Objet : Campagne E280 : EPA21 MX-11/MX13 – Couple incorrect du carter d'huile et de la tubulure d'échappement
DATE D'EXPIRATION : 01/01/2023

E280 - EPA21 MX-11/MX-13 Oil Pan and Exhaust Manifold Incorrectly Torqued

E280

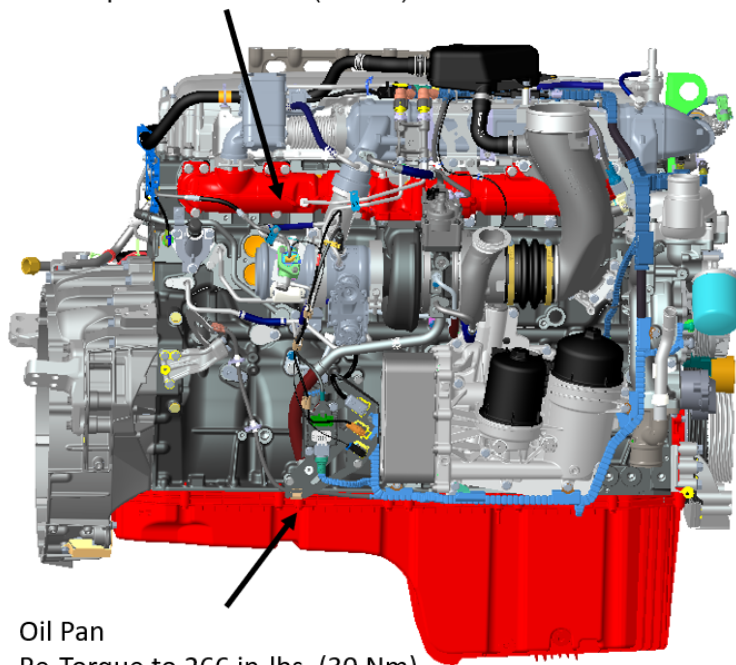
Certain DC tools were incorrectly calibrated. The resulting torque issue could affect the EPA21 MX-11 and MX-13 Oil Pan and/or the Exhaust Manifold.

1. Review the attached chassis list for your dealer code and schedule your customer(s) for service if their chassis is on the list.
2. If you are not using Service Management to start repair orders, review SIR for "Complete" or "In Process" next to the "E280" campaign code prior to performing this repair.
3. Follow the procedures below to re-torque the affected joints that are specified on the attached Chassis List.

Exhaust Manifold
Re-Torque to 531 in-lbs. (60 Nm)

Oil Pan
Re-Torque to 266 in-lbs. (30 Nm)
